Urgent Field Safety Notice
Programmer Software Update
Supporting the Micra™ Transcatheter Pacing System

Model
2090 CareLink™ Programmer
29901 Encore™ Programmer
CareLink Network Application Software 2491

January 2019

Medtronic reference: FA856

Image 1

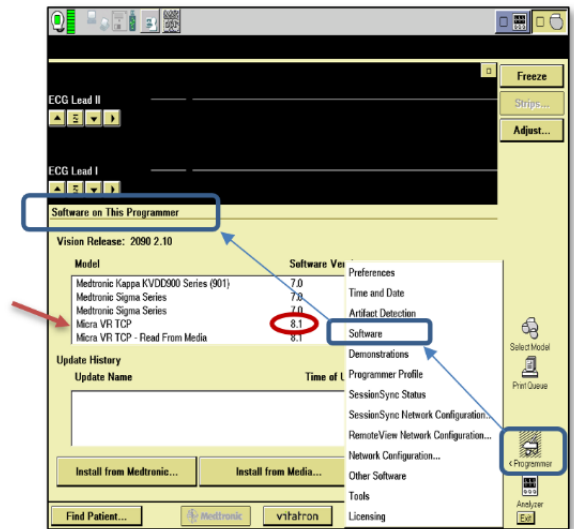
- Select Software (see image 1)
- Scroll through the list of available Software Models in the top selection box until you locate the Micra selection
- Verify the Software Micra VR TCP Version is 8.1

Correct software: Micra VR TCP version 8.1 (or higher)
